**Arboricultural Assessment
Report**

**3643 Channel Highway, Birches Bay,
7162, TAS**

Commissioned by Michela Forthini of Irene Inc on behalf of Julia Stone, Tree Pioneers was engaged to provide an Arboricultural Impact Assessment Report and respond to RFI for 3643 Channel Highway, Birches Bay.

Figure 4. Site plans for the proposed development showing Tree Protection Zones (TPZ). Image shows no encroachment from proposed development.
 Provided by Irene Inc.

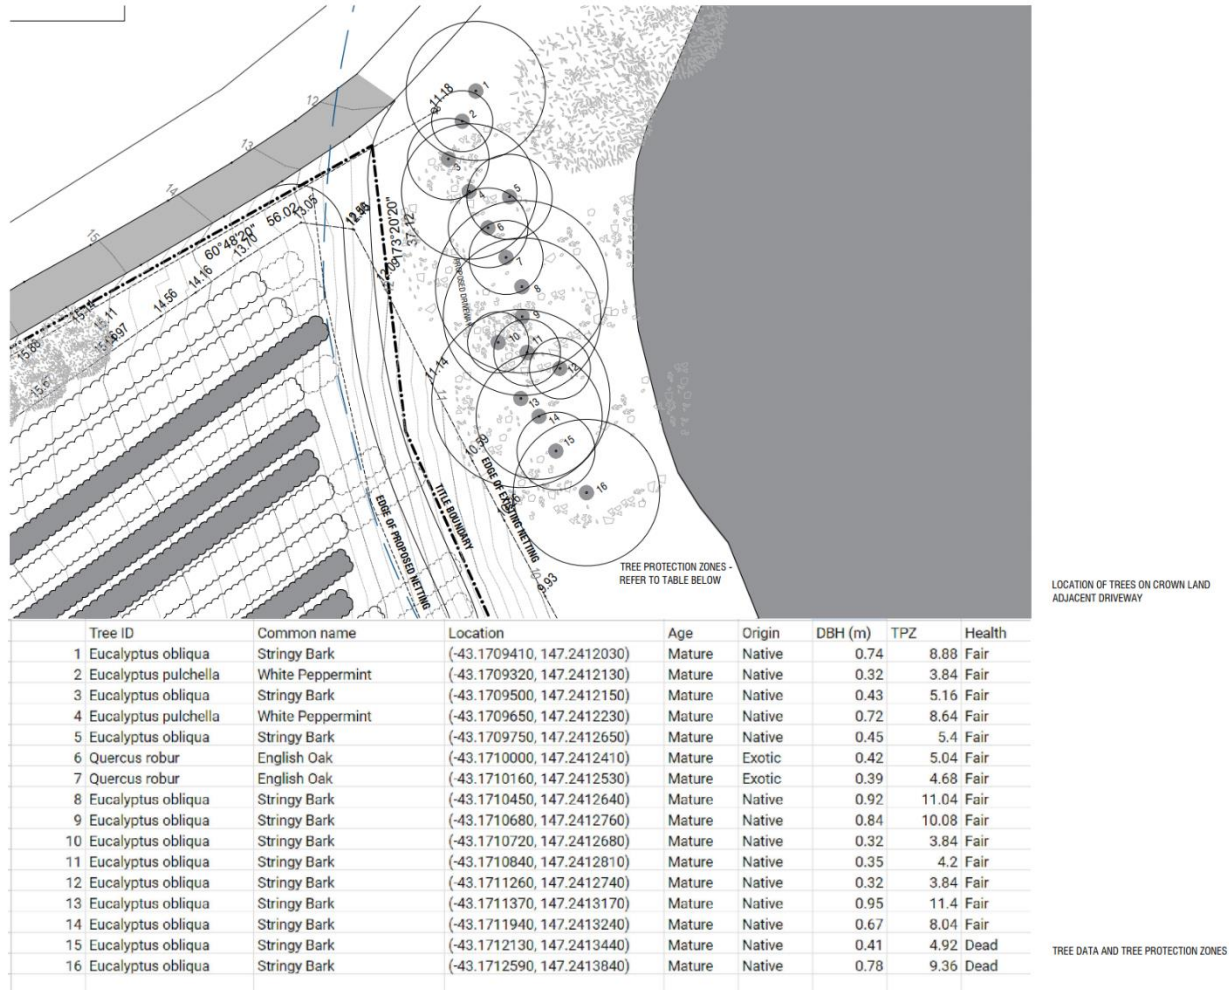
- ***We require a statement that the proposed access along the northeastern boundary will not impact the tree roots or tree health of the adjoining Crown Land.***

The site access has 16 trees on the adjacent crown land that require assessment. None of these trees are impacted by the proposed development. Tree Protection measures are to be erected to ensure the trees remain viable.

The proposed access to the site runs along the northern boundary. The driveway access borders crown land which has 15 large trees. There are no trees with encroachment.

These trees have no encroachment and will not be affected by development.
